# 4TH STREET SW UNDERPASS ENHANCEMENT PROJECT

## WHAT WE'VE HEARD FROM YOU, PART 2.

The Design Charrette I (DCI), held on May 8, marked the second of four opportunities for interested stakeholders to actively participate the in design process. The following handout outlines the key messages we heard that day.

For each of the design mandates (A-G), stakeholders were asked to rate their level of agreement with the following statement: "We believe this concept achieves the design mandate" Comment Matrix

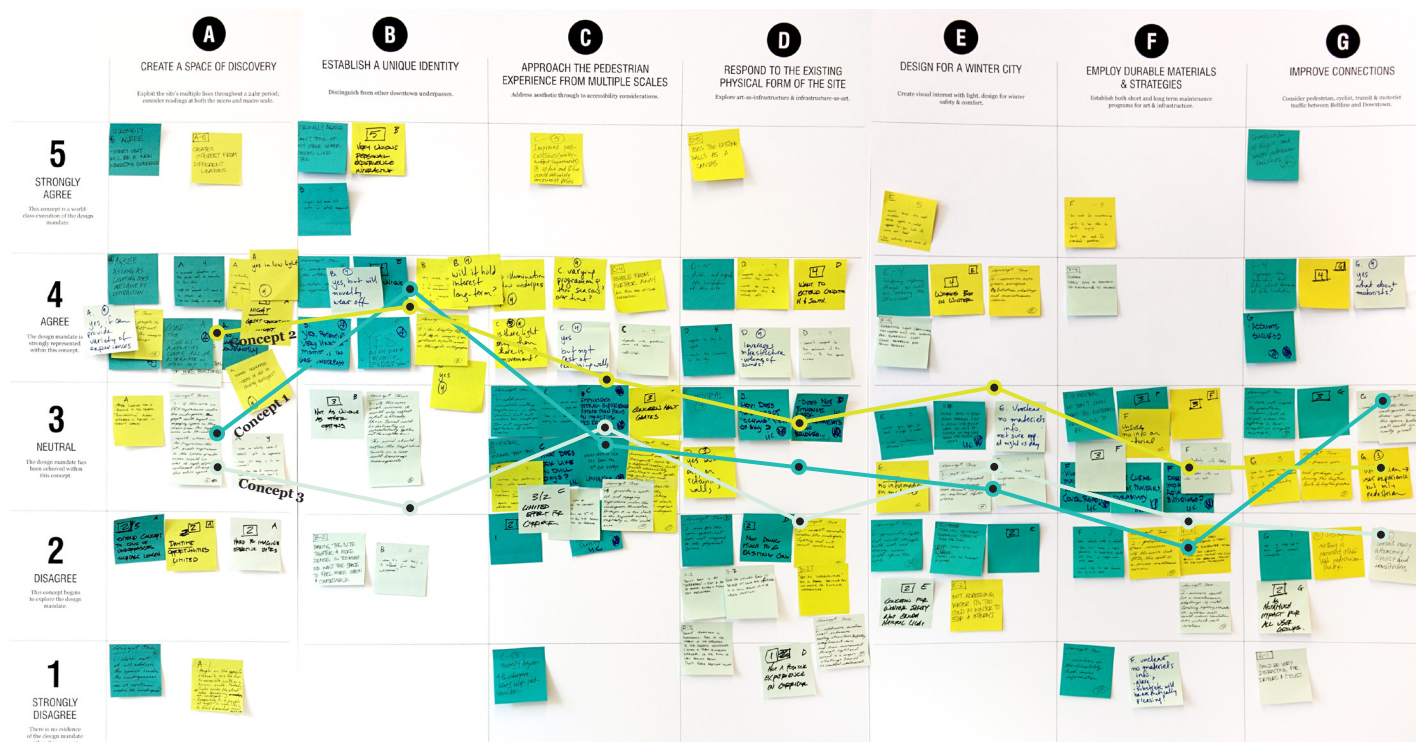
- C1 Yes, Sounds appealing.
- C1 Every visit will be a new, interesting experience.
- C1 Yes, Changes constantly.
- C2 Creates interest from different locations.
- C2 Allows people to discover different places, if the images were to change.
- C2 Constantly changing.
- C3 Yes, it can provide a variety of experiences.
- C1 Does the oculus material cover all, or, alternate with open sky?
- C3 Like that it brings in the sky.

- C1 Increased attention on the blank wall & transition to the sky. People are focused on need to be drawn up, like the strength of our sunlight.
- C1 Extend concept of edge of underpasses, increase length.
- C1 Does not at all address the space under the underpasses, can it continue under the underpasses?
- C3 If this were an LED experience under the underpasses, people could expect an engaging space as they move from the exposed areas into the underpasses; could allow users to experience the at-grade experience in the below grade areas.
- C3 Would be nice if light effect continued through the entire space.
- C3 Like the idea of drawing out from underpass but does it enhance the experience?
- C2 Maybe lighting that is reactive is too dynamic; 'conversation' across underpass is forced - it doesn't happen!

- C2 Yes, in low light: Needs darkness, does it do it during sunlight?
- C2 Day: Daytime opportunities are limited.
- C2 Ensure that experience is still pleasant during the day.
- C3 Hard to imagine effective 24 hours.
- C2 People on the opposite sidewalk are too far to associate with on a human scale/ Nobody looks across the street when traversing an underpass; responding to two people at night is more likely to elicit discomfort than discovery.
- C3 When no activity above it doesn't add to experience; when it's busy, is it too crowded?
- C1 Agree, as long as the lighting does not cause any distraction (Pt 2).
- C3 Don't like reflections of more buildings (Pt 2).

- C1 Can't think of any other underpasses like this.
- C1 Very unique.
- C1 Yes, potentially very unique moment in grey underpass.
- C1 Unique from the other underpasses; relationship to the sky is special.
- C2 Very unique personal experience, interactive.

- C1 Unique - but desire still exists for vertical engagement.
- C3 Not as unique as other options.
- C1 Yes, but not sure @ with technical solutions to achieve effect.
- C2 Will it hold interest in the long term?
- C3 Yes, but will novelty wear off?
- C3 If this was just mirrors, it would only reflect what is already there. Sound could be distracting or overwhelming. Better not to amplify train or road noise. The sound should soften the experience - music on a loop could discourage encampments.
- C3 Making the site tighter and more dense is too much. We want the space to feel more open and comfortable.

- C2 Very unique when activated; is it unique when there is no movement? Is it unique during the day?
- C3 When it's not busy, is it different from other underpasses?

**DESIGN DIRECTION:** Continue to explore methods for shifting experiences within public art. Celebrate the connection to the sky. Take advantage of the spaces beyond the oculus (particularly beneath the bridges) to reinforce the experience. Ensure legibility/activation in both low and high ambient lighting conditions. Consider the scale and experience of the single individual. Ensure lighting does not create a distraction for other users.

**DESIGN DIRECTION:** Consider how programming in conjunction with form can prevent user fatigue/boredom. Explore variable external inputs. Explore the passive experience (where there are no users within the space). Avoid intense soundscapes - space should feel open, comfortable. Develop a higher level of technical resolution.
